# UNITED STATES PATENT AND TRADEMARK OFFICE

APPLICATION NO.	FILING DATE	FIRST NAMED INVENTOR	ATTORNEY DOCKET NO.	CONFIRMATION NO.
10/782,752	02/23/2004	Sang Ho Shin	1594.1345	6177
21171	7590	05/17/2006	EXAMINER	
STAAS & HALSEY LLP SUITE 700 1201 NEW YORK AVENUE, N.W. WASHINGTON, DC 20005			EARLY, MICHAEL JACOBY	
			ART UNIT	PAPER NUMBER
			3744

<b>Office Action Summary</b>	<b>Application No.</b> 10/782,752	<b>Applicant(s)</b> SHIN, SANG HO	
	<b>Examiner</b> Michael J. Early	<b>Art Unit</b> 3744

**DETAILED ACTION**

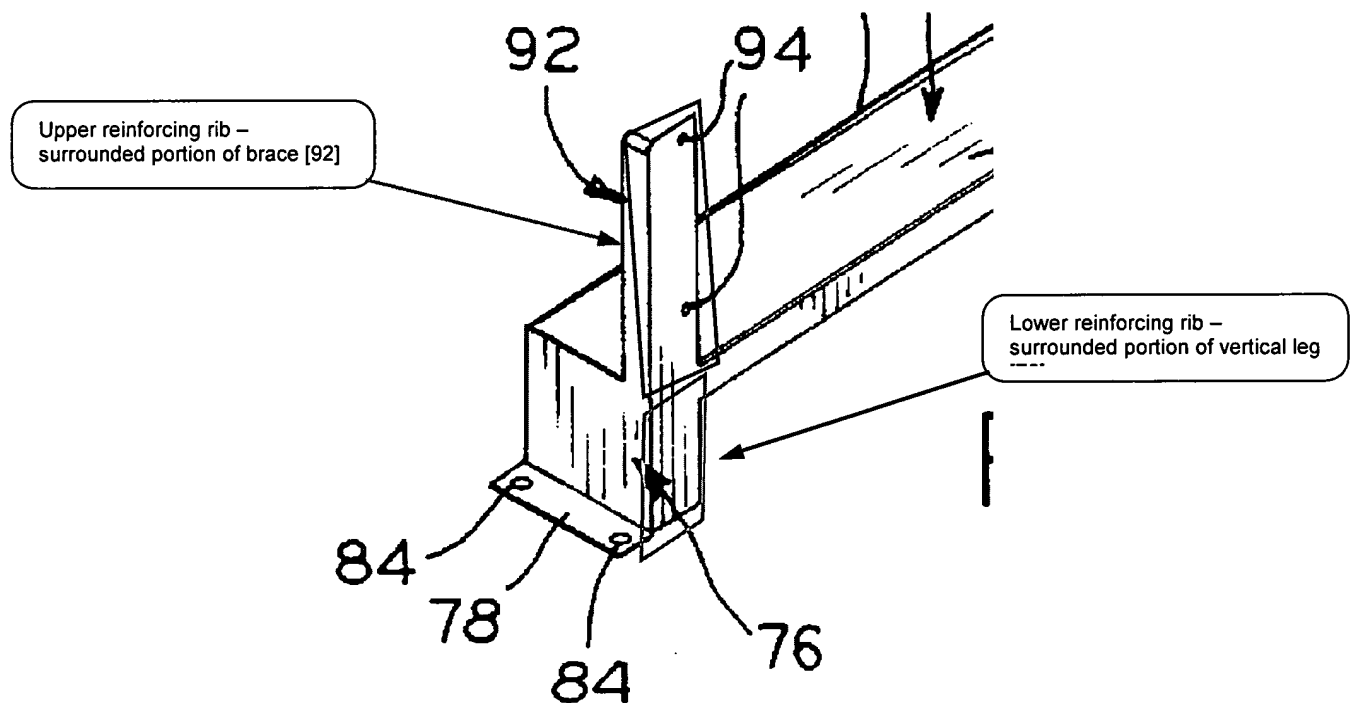
- a spacer member (74 – horizontal support platform) separating a lower end of the outdoor heat exchanger from a seat portion (as seen in the illustration of Figure 3 below) of the bottom panel of the cabinet (as seen in Figure 3);
- to prevent condensed water generated from the outdoor heat exchanger from freezing (intended use).

- a cabinet (44 – cover) having a bottom panel (32 – base plate);
- an outdoor heat exchanger (142 – heat exchange coils) installed in the cabinet (as seen in Figures 2, 3);
- a support member (72 – evaporator mount) including a support portion (74 – horizontal support platform), which supports a lower end of the outdoor heat exchanger (as seen in Figure 3);
  - wherein condensed water flowing on the outdoor heat exchanger falls on the bottom panel via an upper surface of the support portion of the support member (intended use);
  - wherein the support member prevents coldness from the outdoor heat exchanger from being transmitted to the bottom panel to prevent the condensed water from freezing (intended use);

- a cabinet (44 – cover) having a bottom panel (32 – base plate);
- an outdoor heat exchanger (142 – heat exchange coils) installed in the cabinet (as seen in Figures 2, 3);
- a support member which supports the outdoor heat exchanger, including a support portion (74 – horizontal support platform) and a fitting portion (76, 92 – vertical legs, braces);
- wherein the support member includes a plurality of lower reinforcing ribs (as seen in the partial illustration of Figure 8 below) connected between a lower surface of

the support portion and an inner surface of the fitting portion (as seen in Figure 8), and a plurality of upper reinforcing ribs (as seen in the partial illustration of Figure 8 below) connected between an upper surface of the support portion and the inner surface of the fitting portion (as seen Figure 8) and prevents the support portion from sagging (as seen in Figure 8);

FIG. 7

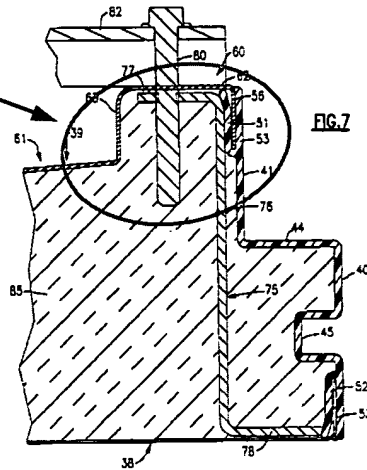
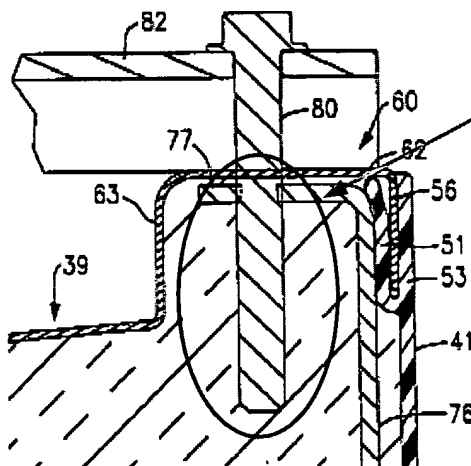
- to prevent condensed water generated from the outdoor heat exchanger from being frozen (intended use);
- the bottom panel of the cabinet includes a flange (as seen in the illustration of Figure 7 below) extending upward at an edge of the bottom panel (as seen in Figure 7 – Figure 7 is an enlarged cross-sectional view of the floor panel [35] as shown in Figure 2), and wherein the support member is attached to the flange (as seen in Figure 7).

- to prevent the support portion from sagging (intended use);
- the support member further includes an upper reinforcing portion (as seen in the first partial illustration of Figure 7 below) connected between an upper surface of

- the fixing portion includes a fitting groove (area in which the stanchion [80] is inserted into the floor panel [35]) into which the flange is inserted to hold the support member (as seen in the second partial illustration of Figure 7 below);

- a cabinet (12 – air handling unit modular sections) having a bottom panel (35 – floor panel);
- an outdoor heat exchanger (30 – air conditioning heat exchanger coil) installed in the cabinet (as seen in Figure 1);
- a spacer member (82 – horizontal beam) separating a lower end of the outdoor heat exchanger from a seat portion (as seen in the illustration of Figure 7 below) of the bottom panel of the cabinet (as seen in Figure 7).
